Development Review Committee (DRC) Meeting

DRC AGENDA

1. CALL TO ORDER
2. ROLL CALL
3. APPROVAL OF MINUTES
 - DRC meeting on June 6th, 2023
4. NEW BUSINESS
 - **Case # 23-04-FSP-Life Storage**; *First Review*, Applicant is requesting approval of a Final Site Plan for the alteration of two existing indoor self-storage buildings to construct a new self-storage building.
5. ADDITIONAL BUSINESS:
6. DISCUSSION:
7. ADJOURNMENT:

The applicant is requesting approval of a Final Site Plan for the redevelopment of 3075 Enterprise Road. Parts of two existing structures would be demolished and replaced with a new structure.

DRAWING NUMBER
 LS-01
 SHEET 01 OF 01

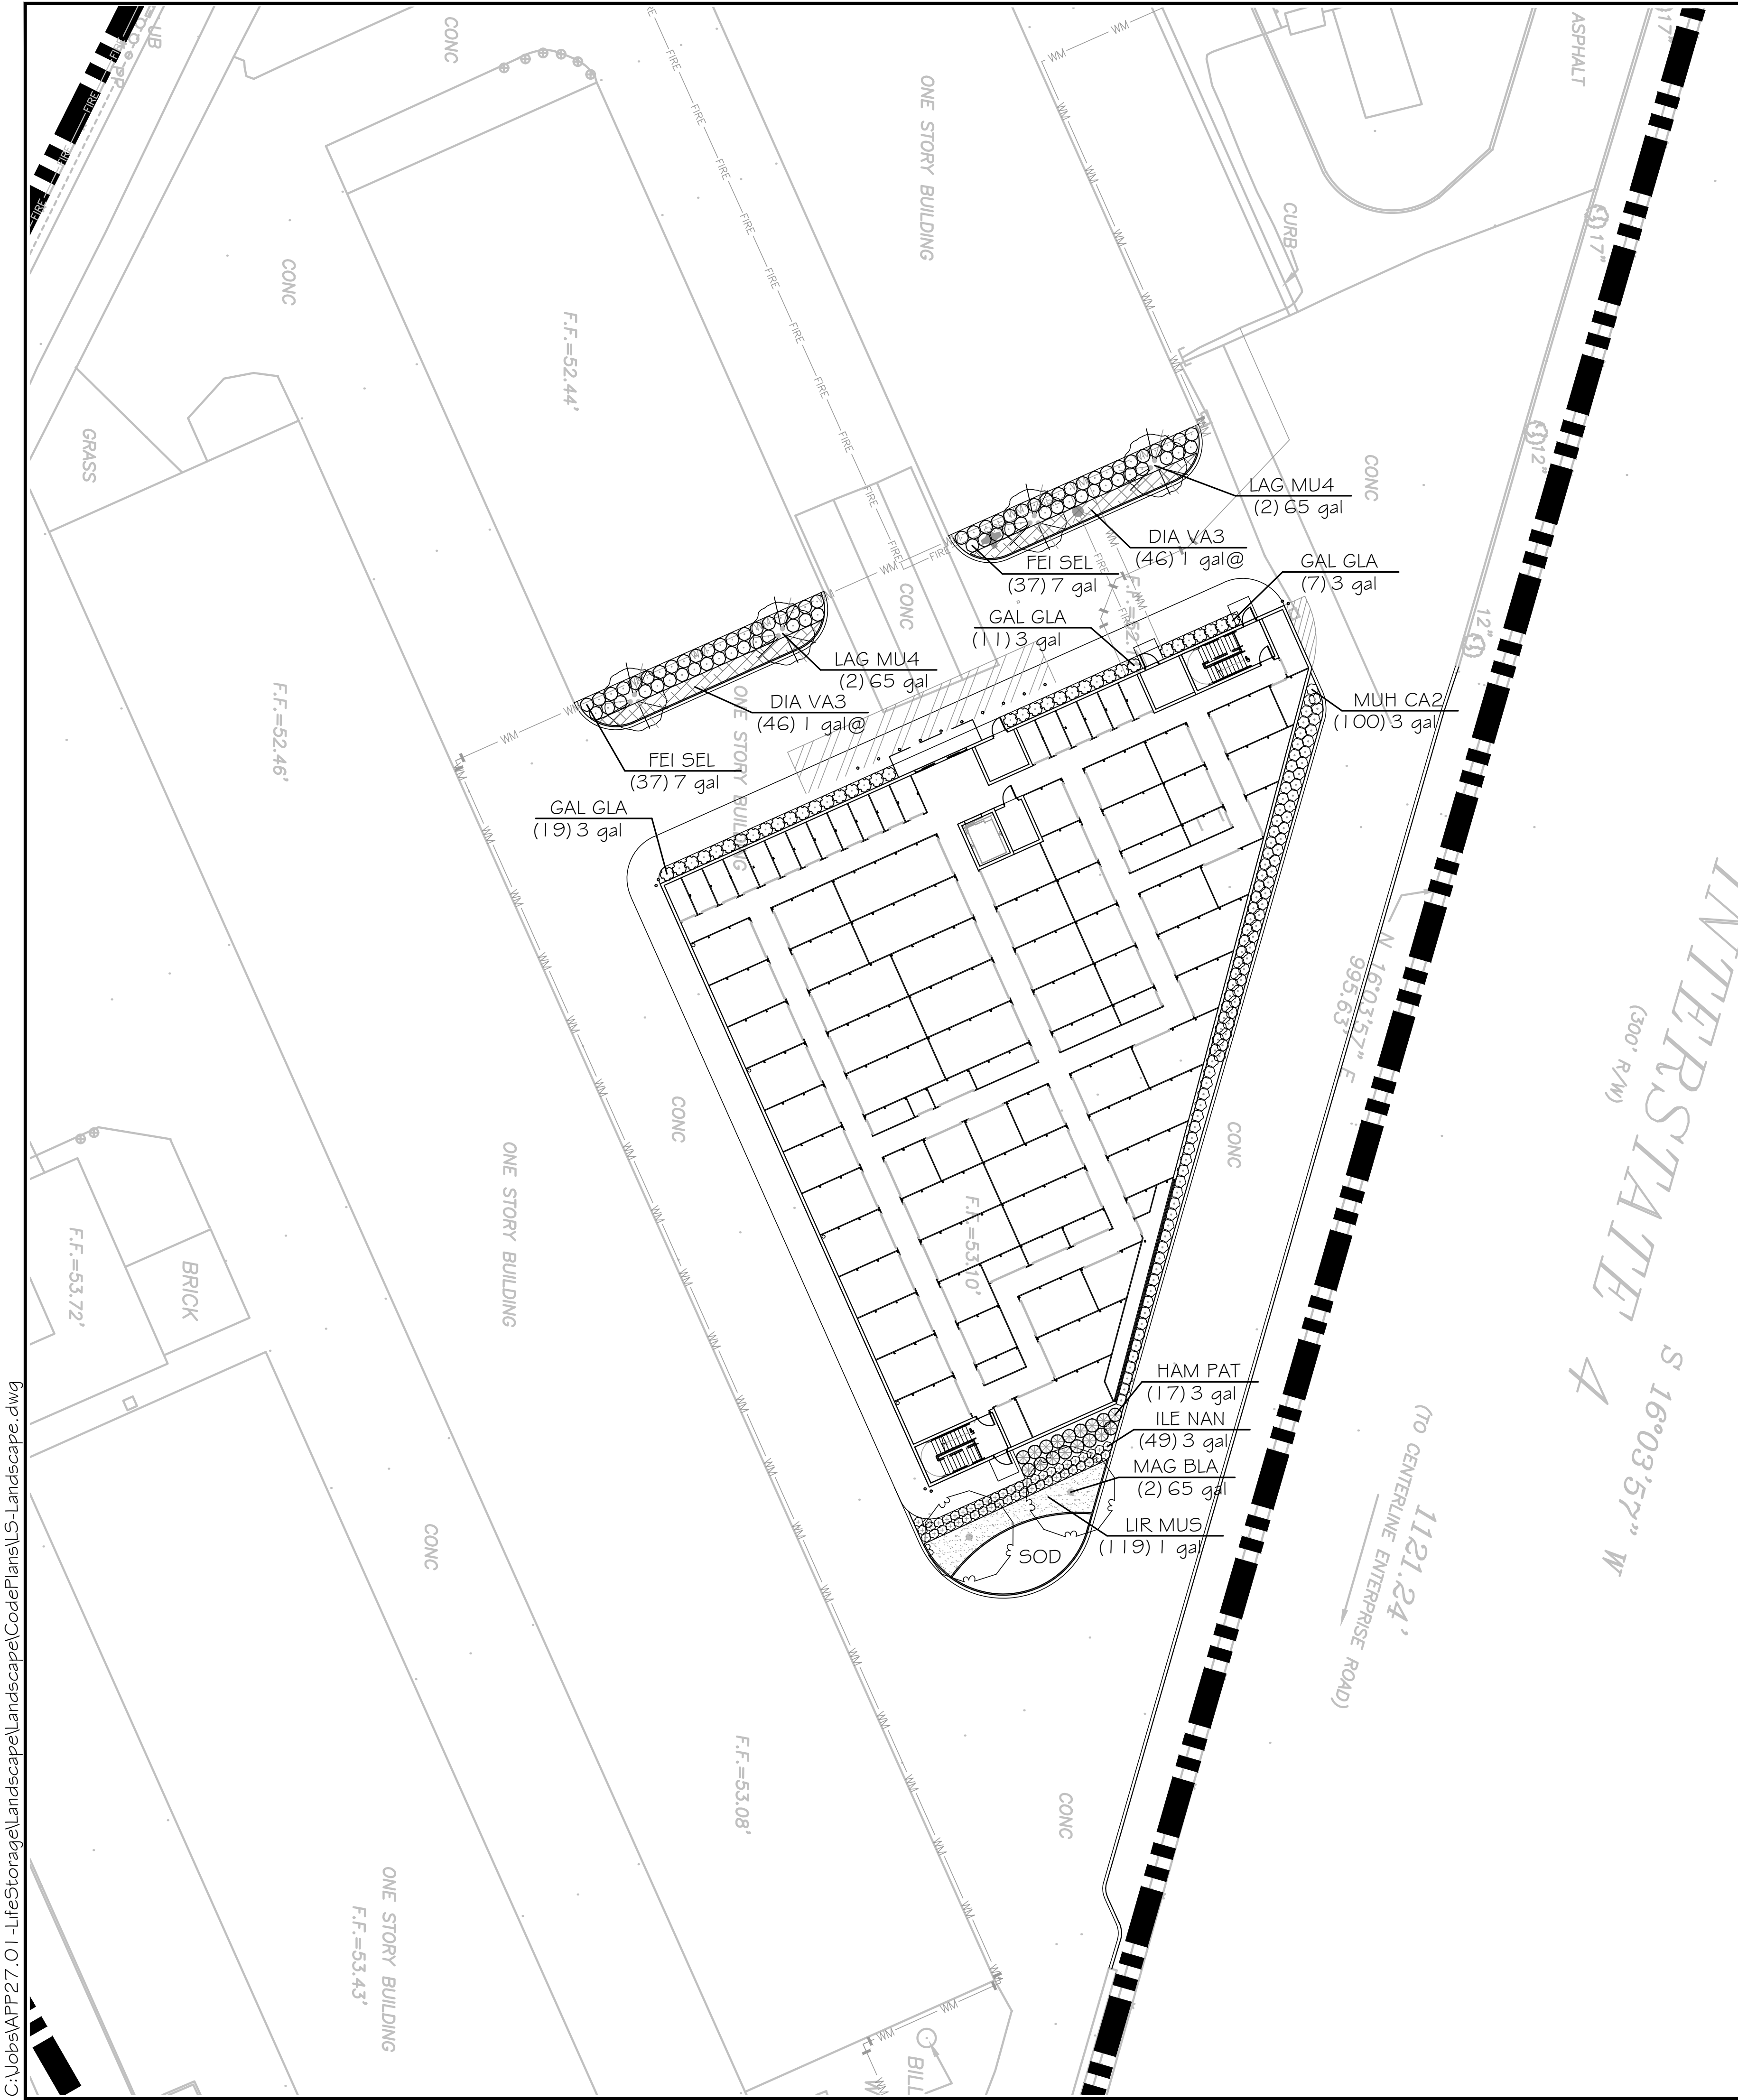
- **A north arrow on Sheet LS-01;**
- **Depiction of the intended direction of traffic flow; and**
- **Depiction of off-street parking, if any is being added.**
